Manfield Preliminary Plan No. 120160360

Staff Report Date: July 10, 2017

Description

Figure 3: Proposed Preliminary Plan

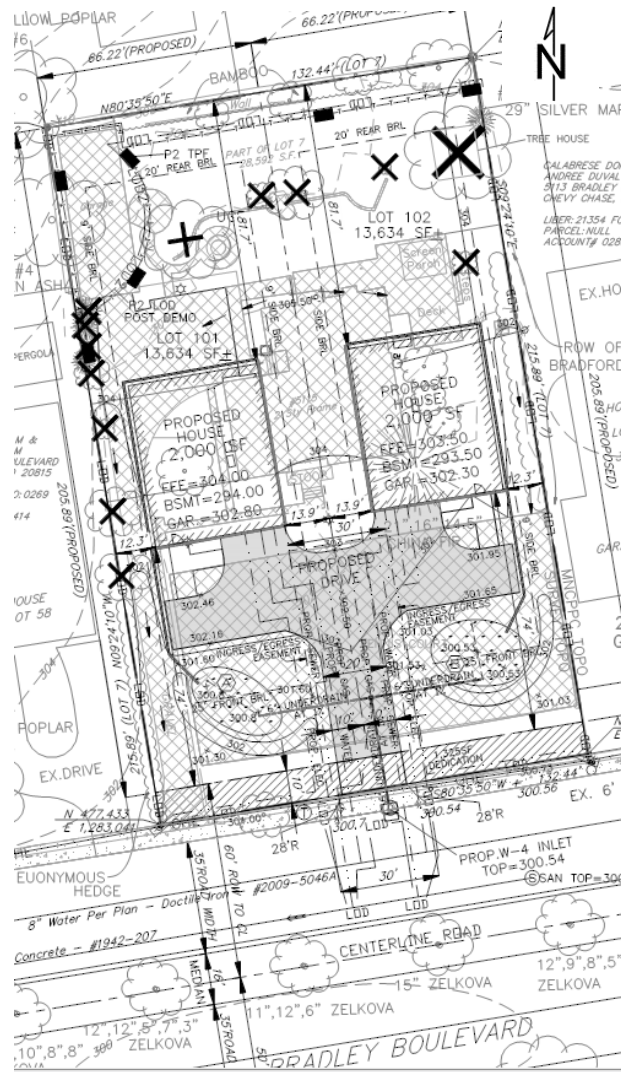
As shown on the submitted Preliminary Plan, the Project will dedicate a 10-foot wide strip across the site's entire frontage for a total of 1,325 square feet. This dedication will provide the minimum width of 60 feet between the property line and the MD 191 right-of-way centerline. This dedication supports the Master Plan recommendation for a right-of-way width of 120-feet on MD 191 and is a recommended condition of approval.

The Project proposes eliminating the site's existing driveway from MD 191 in favor of a single right-in/ right-out shared driveway located in the middle of the site's frontage on MD 191, approximately 53 feet east of the existing driveway. The proposed access concept is preferable to the existing condition because it consolidates access to a single point between the two proposed lots.

Currently, the proposed driveway location is improved with a storm drain inlet that must be relocated outside of the proposed driveway apron to facilitate safe and adequate vehicular ingress/ egress. MSHA may permit the driveway to be constructed around the existing inlet or in the alternative require the Applicant to relocate the inlet along the site's frontage. Staff recommends a condition of approval to address the storm drain inlet.

7. The record plat must show a common access easement from Bradley Boulevard (MD 191) over the shared driveway.
8. Prior to recordation of plat, the Applicant must satisfy the provisions for access and improvements as required by Maryland State Highway Administration (MSHA) including relocating the existing storm drain inlet outside the limits of the proposed driveway apron, unless this requirement is waived by MSHA.

9. The Applicant must dedicate 10-feet along the Subject Property’s frontage as mandated by the 1990 *Bethesda-Chevy Chase Master Plan* and as shown on the Preliminary Plan.
